**PZ&B Staff Combination Memorandum: Landmarks Preservation Commission and Town Council**

**SUBJECT:** COA-24-001 (ZON 24-020) 930 S OCEAN BLVD (COMBO)

**MEETING:** JANUARY 17, 2024, LPC  
FEBRUARY 14, 2024, TOWN COUNCIL

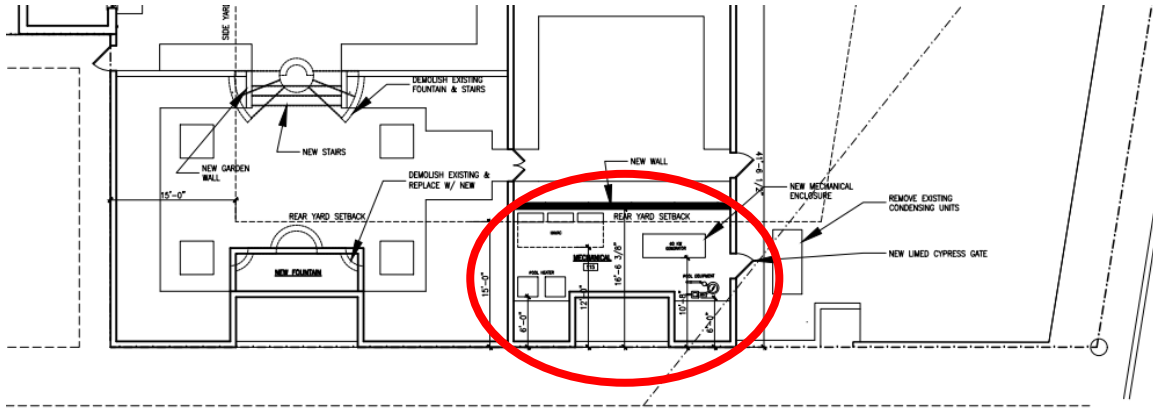
As it pertains to the variance requests (#1), the applicant is proposing to construct a small, one-story addition “connecting” two existing components of the two-story landmarked residence. The two-story primary residence facing north along Via Bellaria. Currently a one-story detached guest house is located behind the primary residence. The applicant is proposing to “infill” approximately 70 SF of new enclosed space that would serve as a connection between the garage and the guesthouse. Both the primary residence and the one-story guesthouse have a nonconforming west side setback of 2.8’ that the applicant would like to create a linear extension.

The extension of the nonconforming side setback requires variance relief of 12.2’, as the required side setback is 15’.

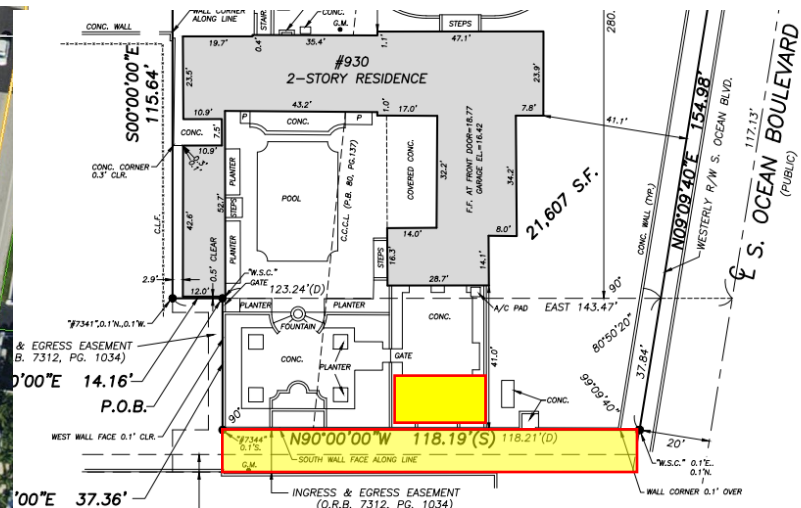
As it pertains to the variance requests (#2-4), the applicant is seeking to modify the existing concrete yard located in the south side of the site and create a mechanical equipment yard.

The R-A zoning district has a required rear yard setback requirement of 15'. The applicant is proposing to place permit three (3) pieces of air conditioning equipment within the south rear yard setback in lieu of the two (2) pieces of air conditioning equipment maximum permitted. Additionally, the new pool equipment is proposed to be placed within the equipment yard.

Yet when placed within the setback the Code requires the equipment to be spaced no further than 25' to the water's edge of the pool (variance #3). Additionally, the pool heater is proposed to be setback 6' from the south property line instead of the required 10' (variance #4). An existing site wall and planters should serve as adequate buffering for the equipment.

Further, the proposed mechanical equipment yard location is ideal in terms of impact to neighbors—it's proposed siting abuts the western neighbors' property's 15' wide access easement. And the proposed adjacent to the abutting property's vehicular storage area, which should preclude any audible or visual impact upon the neighbor.
